Serial No. **09/978,550**

Docket No. **HI-0046**

Reply to Office Action dated September 21, 2005

AMENDMENTS TO THE DRAWINGS

FIG. 1

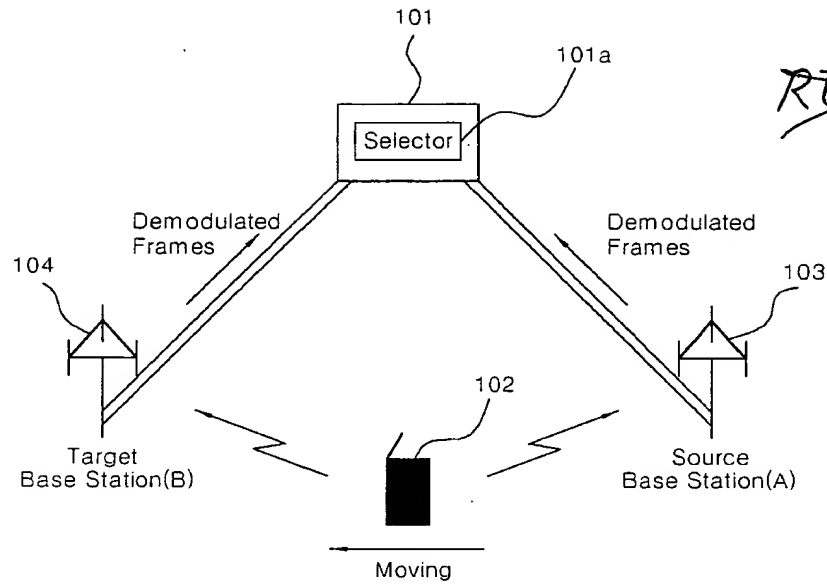
The Office Action states that FIGs. 1-5 should be labeled as "Prior Art." In order to further prosecution, each of FIGs. 1-5 has been labeled as "PRIOR ART." This is not an admission as to prior art.

*PRIOE
RELATED ART*
